Access Compliance Report

Public Rights-of-Way

(Curb Ramps)

Intersection ID: 50611	Main Street: COTTON_GUM_RD	Cross Street: DOWNY_BIRCH_RD	Location: NE
ADA ID: 1C17661602DB	Ramp Type: Perp	Initial Pass/Fail: Fail	Overall Compliance: No
Severity Score: 12.5			
Codes/Mitigation Info/Possible Solution		Field Measurements/Component Compliance

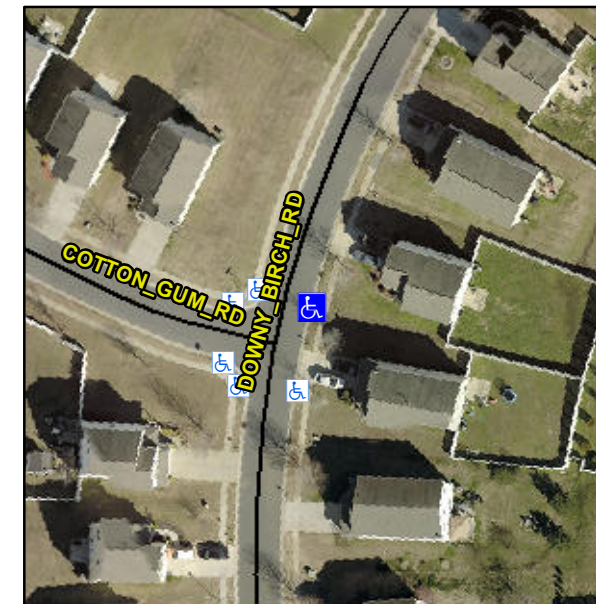
Not Found, R304.2.2

Compliance	Description	Data	Compliance	Description	Data
N/A	Ramp Length (in)	47.0	No	Ramp Slope (%)	8.8
Yes	Ramp Width (in)	48.0	Yes	Ramp XSlope (%)	1.4
N/A	Flare Type LT	N/A	N/A	Flare Type RT	N/A
N/A	Flare Slope LT (%)	N/A	N/A	Flare Slope RT (%)	N/A
N/A	Flare Traversable LT?	N/A	N/A	Flare Traversable RT?	N/A
N/A	Landing Length (in)	N/A	N/A	DWS Provided?	N/A
N/A	Landing Width (in)	N/A	N/A	DWS Contrast?	N/A
N/A	Landing Slope (%)	N/A	N/A	DWS Length (in)	N/A
N/A	Landing X Slope (%)	N/A	N/A	DWS Full Width?	N/A
N/A	Landing Curb? (Y/N)	N/A	N/A	DWS Offset (in)	N/A
N/A	Shared Landing?	N/A			
N/A	Gutter Ponding?	N/A	N/A	Gutter Slope (%)	N/A
N/A	Gutter Lip Ht (in)	N/A	N/A	Gutter X Slope (%)	N/A
N/A	Painted X Walk1?	No	N/A	Painted X Walk2?	N/A
	X Walk 1 Direction	To NW		X Walk 2 Direction	N/A
N/A	X Walk 1 Width (in)	N/A	N/A	X Walk 2 Width (in)	N/A
	X Walk 1 Slope (%)	0.3		X Walk 2 Slope (%)	N/A
	X Walk 1 X Slope (%)	1.2		X Walk 2 X Slope (%)	N/A

Remove & Replace Entire Ramp.
